**MOORE PUBLIC SCHOOLS -
OLD SCHOOL REPLACEMENT**

ADDENDUM NO. 1

April 2, 2026

LIFE SAFETY PLAN - SECOND FLOOR

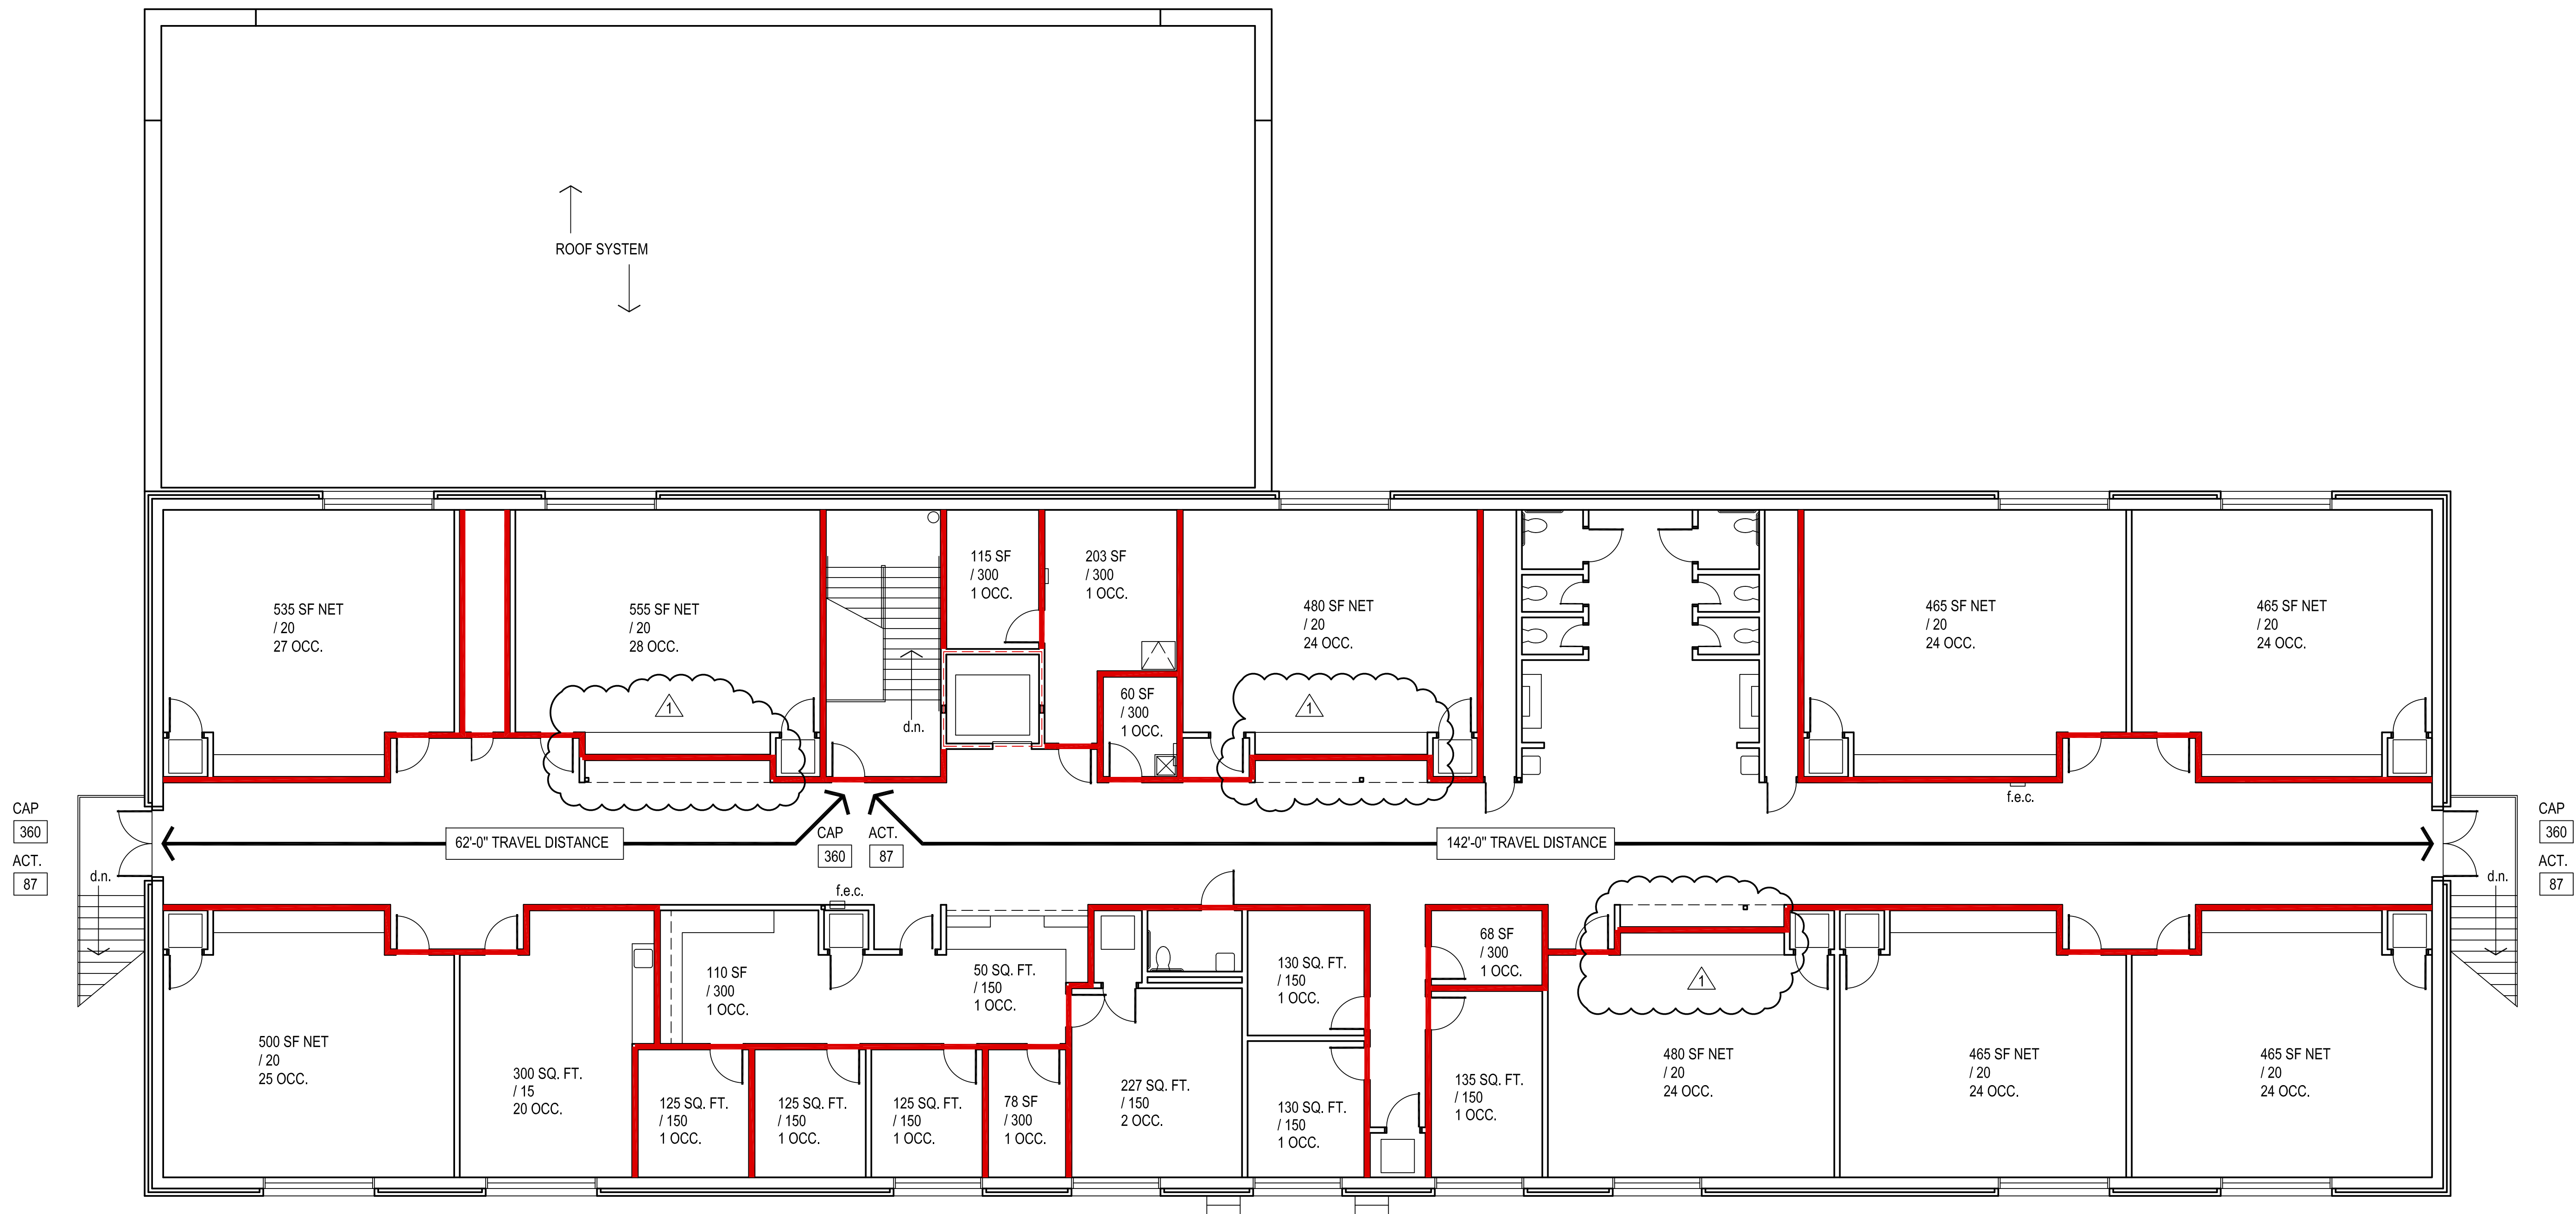
1. Sheet A101, Detail #1, Life Safety Plan – Second Floor: revised floor plan areas for display / trophy cases as per attached drawing.

A102

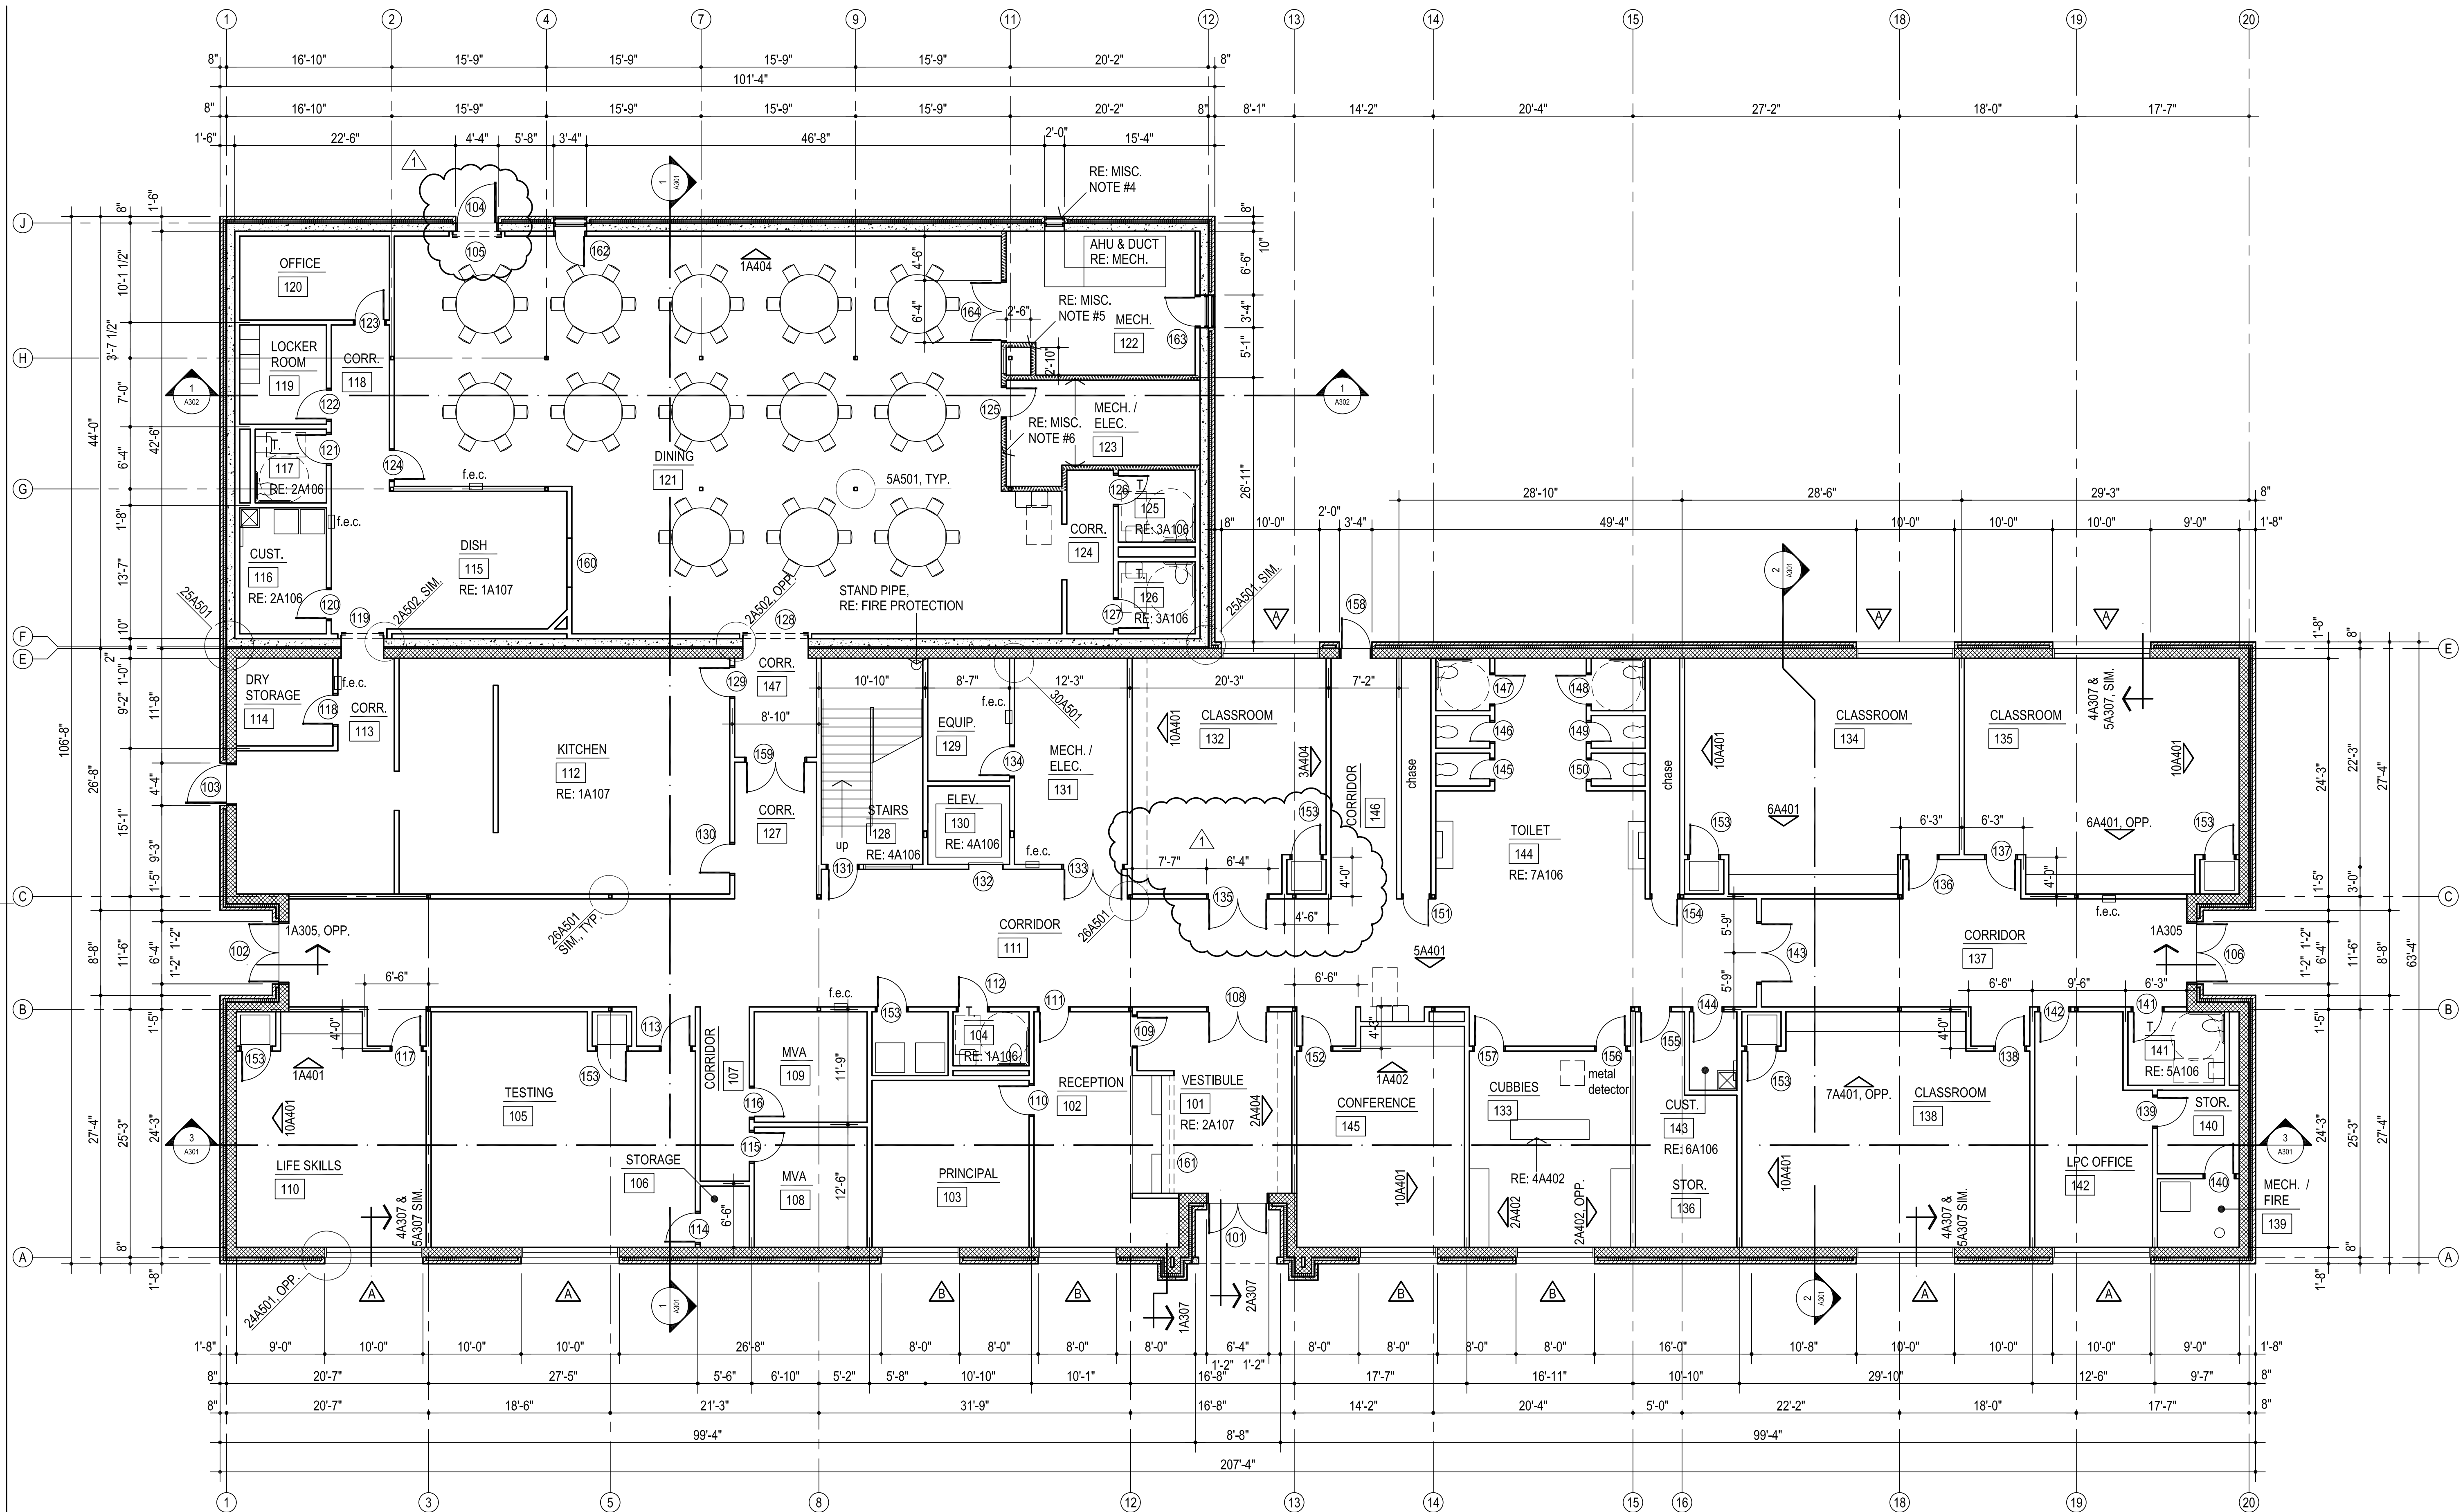
2. Sheet A102, Detail #1, First Floor Plan and Sheet A103, Detail #1, Second Floor Plan: revise rooms / areas as noted to allow for installation of display / trophy cases. Refer to attached revised drawings.

3. Sheet A102, Detail #1, First Floor Plan: added coiling tornado Door #105 between Room #121 and the exterior. Refer to attached revised drawing.
4. Sheet A104, Detail #1, Reflected Ceiling Plan – First Floor and Sheet A105, Detail #1, Reflected Ceiling Plan – Second Floor: revise rooms / areas as noted to allow for installation of display / trophy cases. Refer to attached revised drawings.

S. WALL ROOM #101
1/4" = 1'-0"

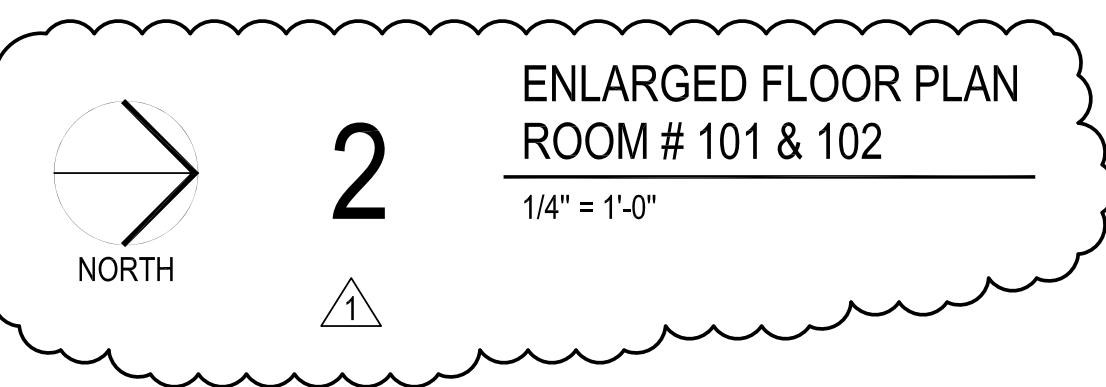
6. Sheet A107, Detail #3, South Wall Room #101: revised vertical detail reference number as indicated. Refer to attached revised drawing.
7. Sheet A109, Detail #1, First Floor Equipment Plan and Sheet A110, Detail #1, Second Floor Equipment Plan: revise rooms / areas as noted to allow for installation of display / trophy cases. Refer to attached revised drawings.

ENLARGED FLOOR PLAN
ROOM # 101 & 102
1/4" = 1'-0"

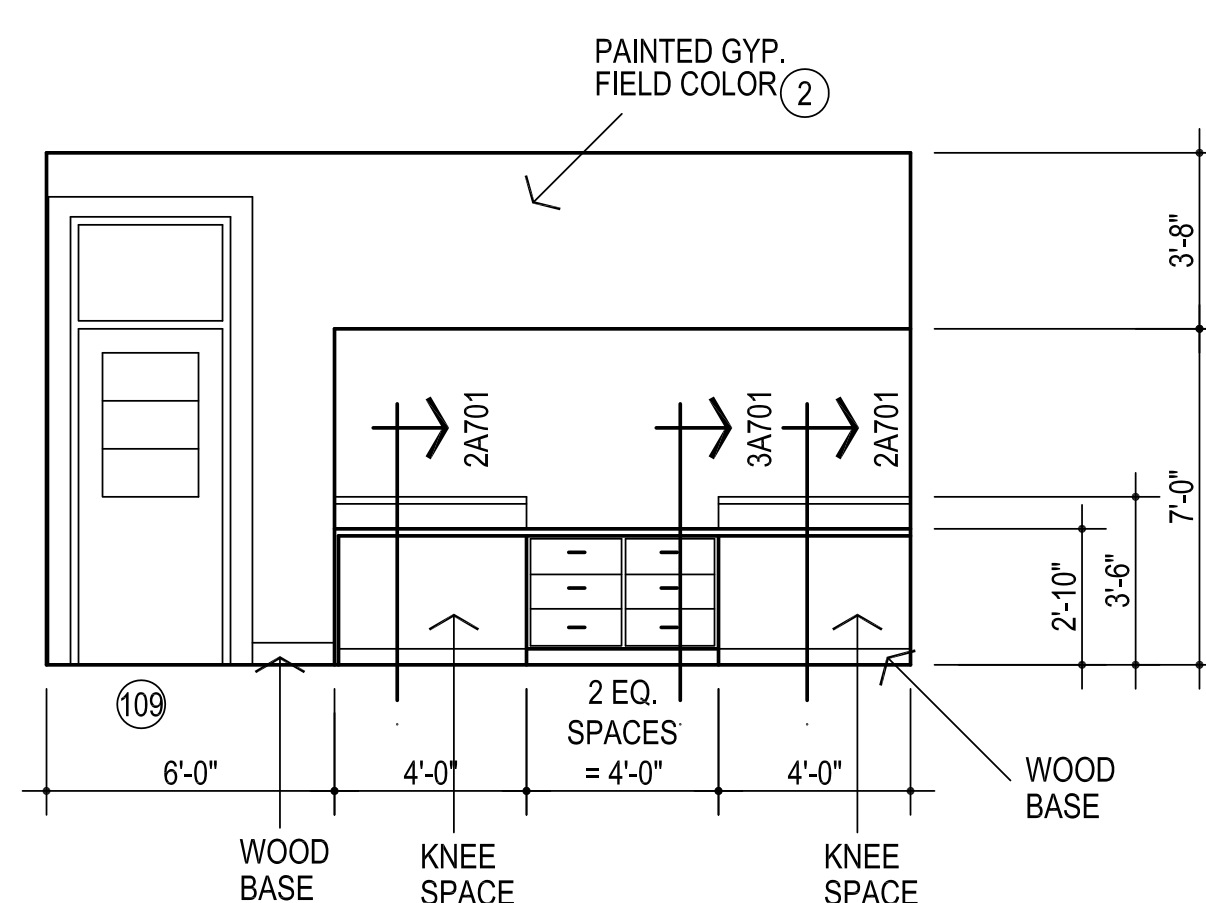
5. Sheet A107, Details #2, Enlarged Floor Plan Room #101 & 102: revise rooms / areas as noted to allow for installation of display / trophy cases. Refer to attached revised drawings.
